UNITED STATES OF AMERICA  
NUCLEAR REGULATORY COMMISSION

In the Matter of	)	
	)	
LONG ISLAND LIGHTING COMPANY	)	Docket No. 50-322-0L
	)	
(Shoreham Nuclear Power Station,	)	
Unit 1)	)

SUPPLEMENTAL TESTIMONY  
OF  
SPENCER H. BUSH AND ADAM J. HENRIKSEN  
CONCERNING  
CYLINDER BLOCKS OF THE TDI EMERGENCY DIESEL GENERATORS  
AT THE  
SHOREHAM NUCLEAR POWER STATION

CAMSHAFT GALLERY SADDLE

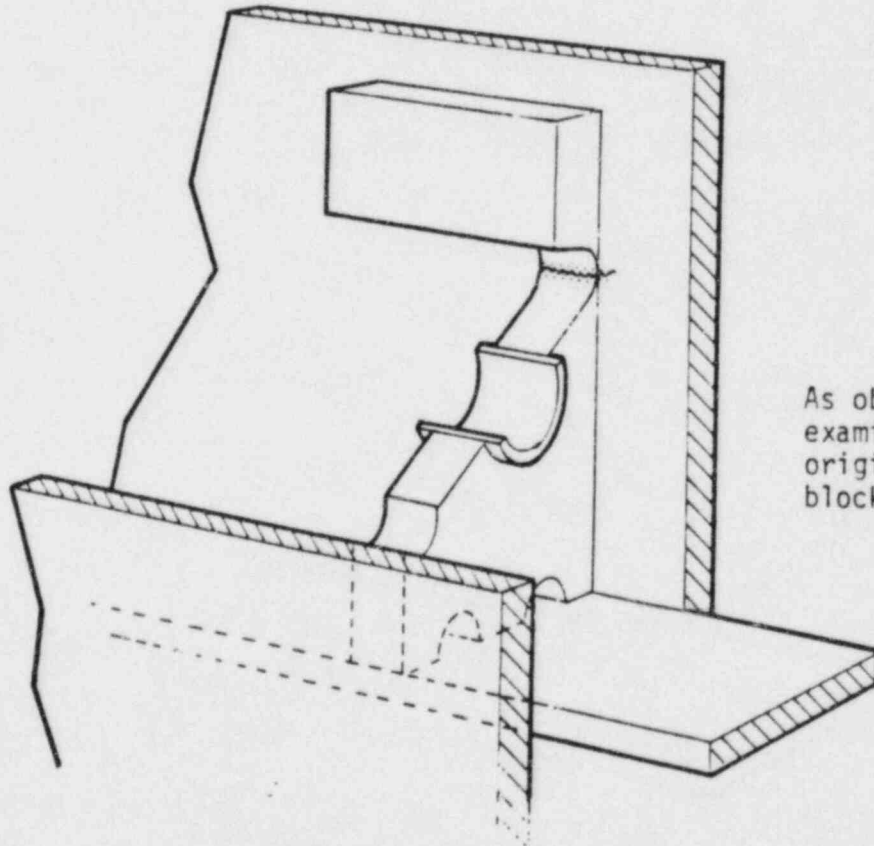
Our perception of the geometry of the bearing saddles in the cam gallery was based on an examination of TDI engine drawings. An examination of the original EDG 103 block on Friday, September 21, revealed that our interpretation was incorrect. The attached figure presents the actual versus the perceived geometries. In the actual geometry, the high compressive stresses from bolt-up of the cylinder block to the engine base should neutralize or exceed the alternating tensile and/or bending stresses in the vicinity of the cracks. Our perceived geometry approximated a cantilever, so the vector of cam loads would always be positive. The latter geometry could result in continued growth of the existing cracks.

As perceived in  
preparation of  
original testimony

As observed in  
examination of  
original EDG 103  
block on 9/21/84
